EPA Superfund Explanation of Significant Differences:

**CHEMICAL SALES CO.
EPA ID: COD007431620
OU 01
DENVER, CO
03/27/2000**

**CHEMICAL SALES COMPANY SUPERFUND SITE
OPERABLE UNIT I - PLUME AREA
EXPLANATION OF SIGNIFICANT DIFFERENCES**

March 2000

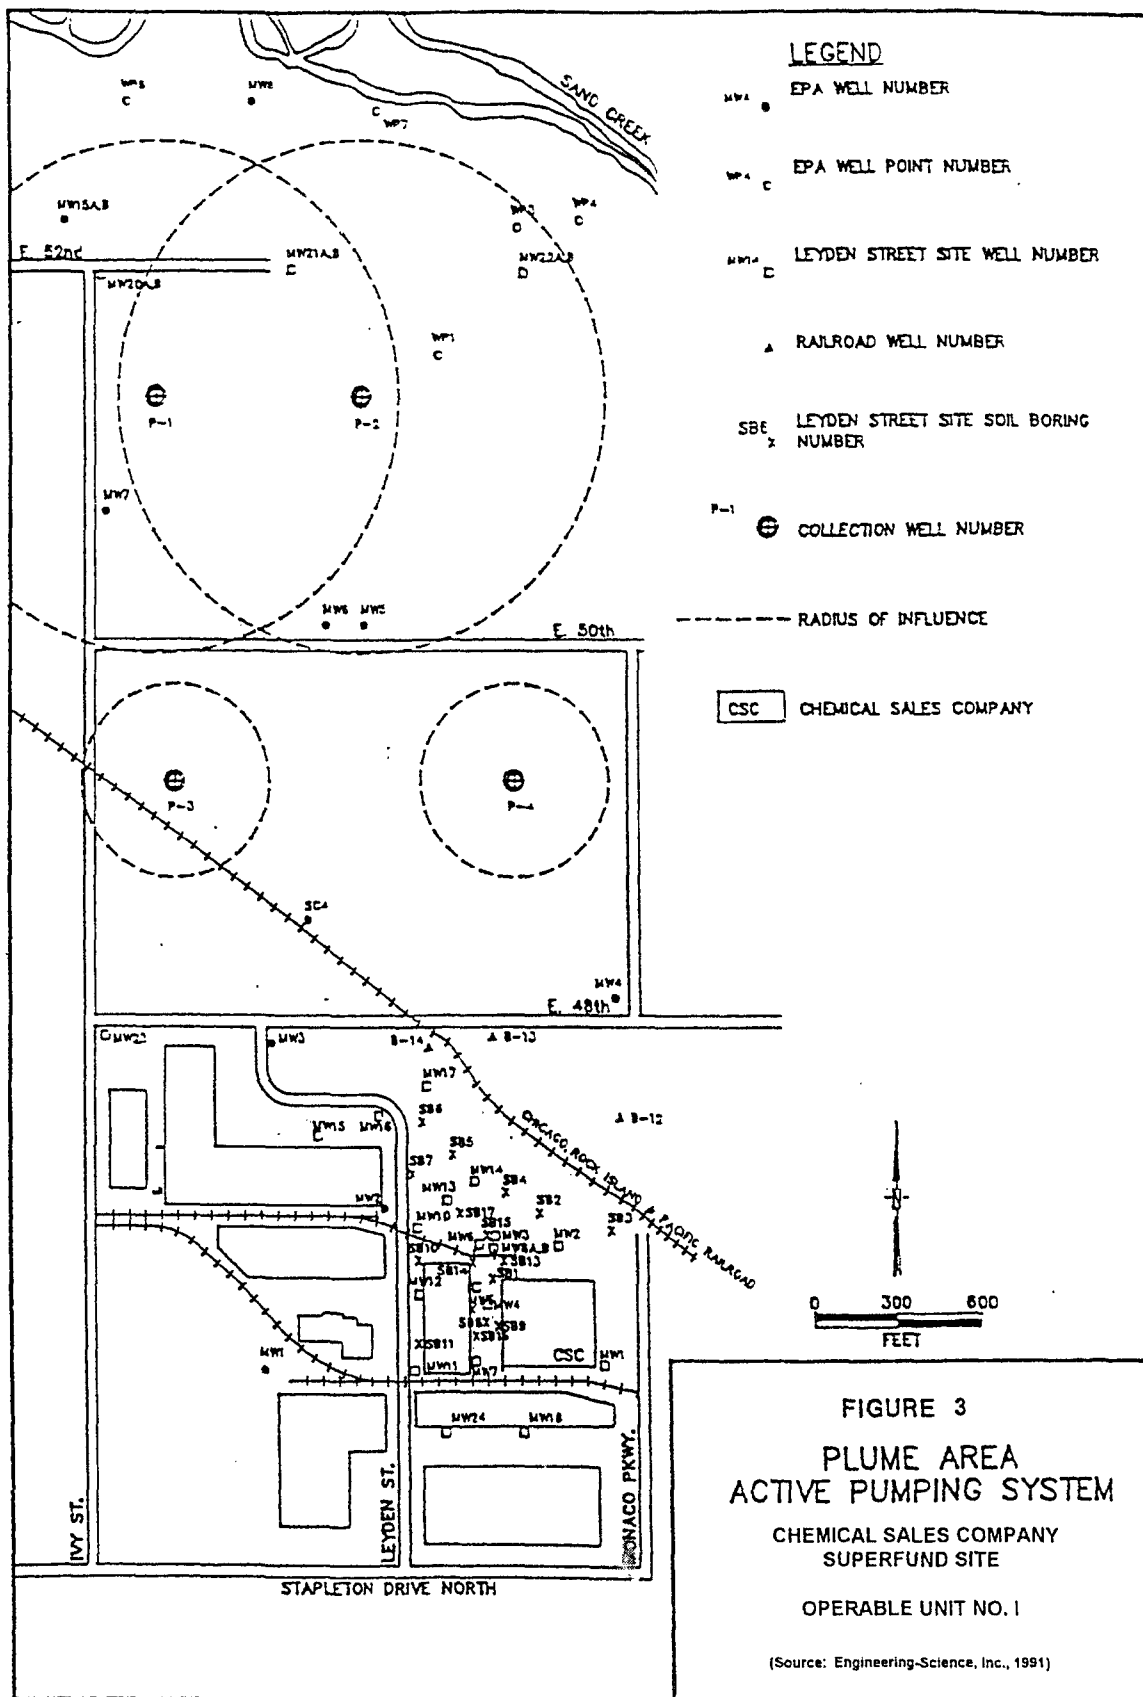
- < Monitoring ground water, discharged treated water and air;
- < Notification by the Colorado State Engineer's Office of the potential health risks associated with use of contaminated ground water upon request for an alluvial well permit within the OU1 area;
- < High volume (1,000 gpm) ground water extraction within the CSC plume area (area north of East 48th Avenue and south of Sand Creek);
- < Treatment of contaminated ground water with an air stripping tower located near East 52nd Avenue; and
- < Reinfiltration of treated ground water through discharge into a trench or gravel pit for the plume area.

Basis for Change. During design activities, new information from hydrogeologic investigations indicated that the selected remedy would be less efficient and effective at accomplishing remediation goals. The design hydraulic conductivity value (K value), derived from ground water pumping tests, was significantly less than the value reported in the RI/FS and used in the ROD. The change in the K value and in the saturated thickness of the more permeable zones resulted in a significant reduction in the predicted radii of influence, or capture zone, for ground water extraction wells. The lateral capture zone predicted in the RI/FS and ROD was as much as 900 feet per extraction well. The new information led to a lateral capture zone of only 25 to 50 feet per well. This reduction in the capture zone would require that the four extraction wells required in the ROD be increased to 61 extraction wells. Instead of drawing ground water from the entire plume area, as the wells required by the ROD were intended, the significantly reduced capture zone required that the 61 extraction wells be arranged in a line along East 52nd Avenue. This allowed contaminated ground water to be collected only after it had already migrated naturally to within 50 feet of East 52nd Avenue.

Remedial design ground-water pumping tests showed that achievable pumping rates were 10 to 20 times less than estimates from the RI/FS (7 versus 80 gpm for the shallow zone and 0.25 versus 5 gpm for the deep zone). Even with 61 wells instead of the four required by the ROD, the ground water extraction rate was reduced from 1,000 gpm required by the ROD to 375 gpm.

Evaluation of Third Option. Further design investigations were performed to evaluate a third option, monitored natural attenuation in the plume area. New sampling data from the investigation indicates that the contaminant plume is no longer increasing in extent and is shrinking. The evaluation of the plume area ground water determined that no significant biodegradation of contaminants is occurring, but contaminant concentrations in ground water have decreased by a factor of ten over the past several years due to dispersion, dilution, and sorption of contaminants onto the soil matrix. These processes are among the natural attenuation mechanisms identified in EPA's guidance on monitored natural attenuation. Monitored natural attenuation reduces potential risk at the site by reducing contaminant concentrations, thereby reducing potential exposure levels. EPA guidance suggests that monitored natural attenuation would be appropriate for this component of the remedy because:

Selected Option: Monitored Natural Attenuation. The selection of monitored natural attenuation will meet all applicable or relevant and appropriate requirements identified in the ROD. There are no action-specific or location-specific requirements for monitored natural attenuation. Chemical-specific requirements, including federal MCLs and State of Colorado Basic Standards for Ground Water apply, and would be met in approximately the same time frame that pumping and treatment would require, when uncertainty in the sophisticated model is considered. The ground water remediation levels identified in the ROD remain unchanged. Ground water will be monitored until remediation levels have been achieved.
